UNITED STATES PATENT AND TRADEMARK OFFICE
CERTIFICATE OF CORRECTION

PATENT NO. : 6,879,841 B2
APPLICATION NO. : 10/086330
DATED : April 12, 2005
INVENTOR(S) : Ozluturk et al.

**FIG. 2**

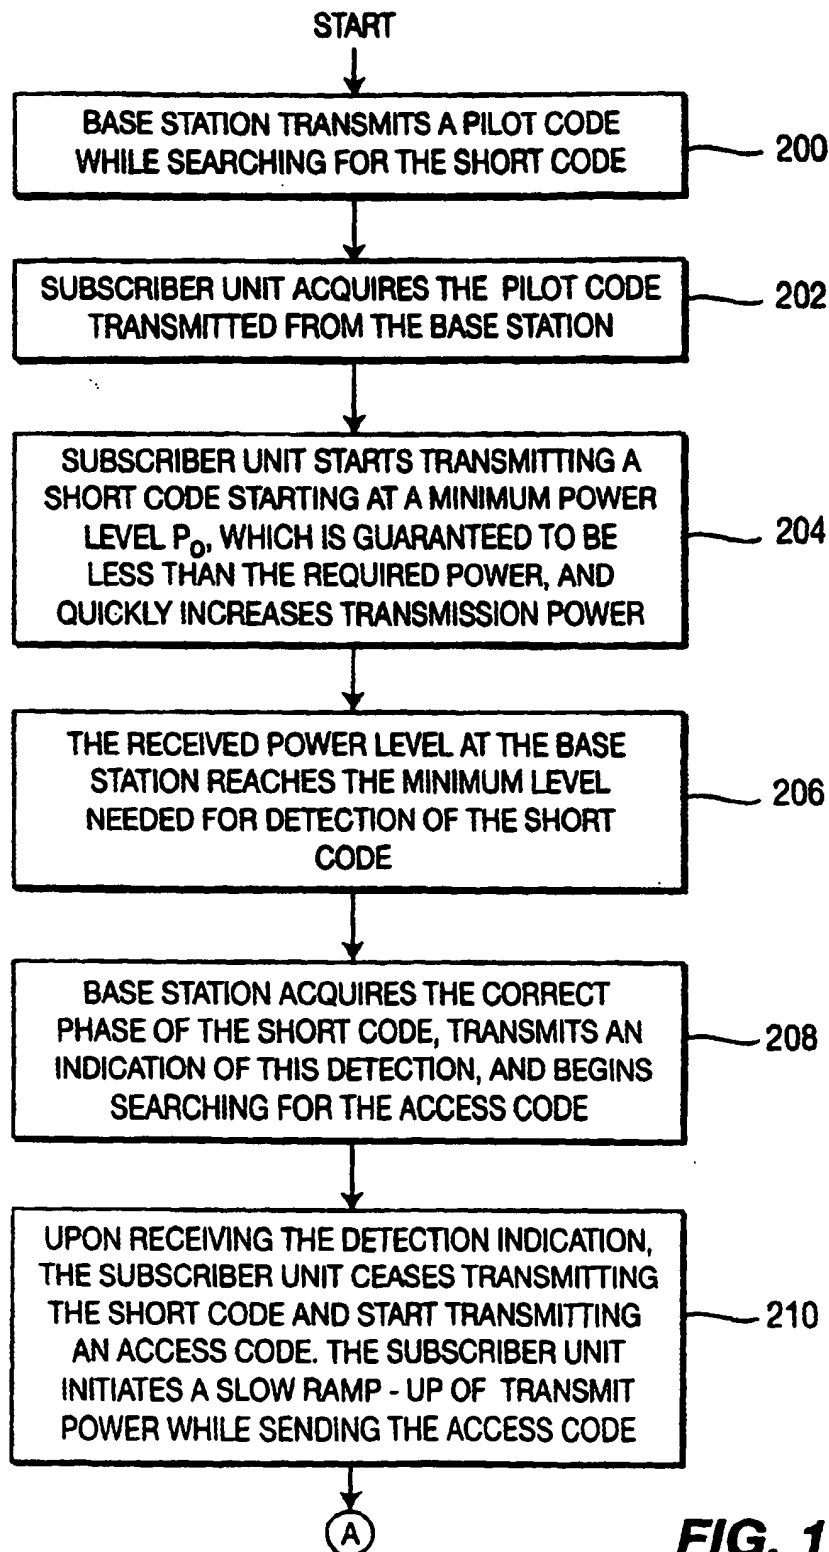
Please replace Figures 2, 11A, and 11B with replacement Figures 2, 11A, and 11B attached hereto.
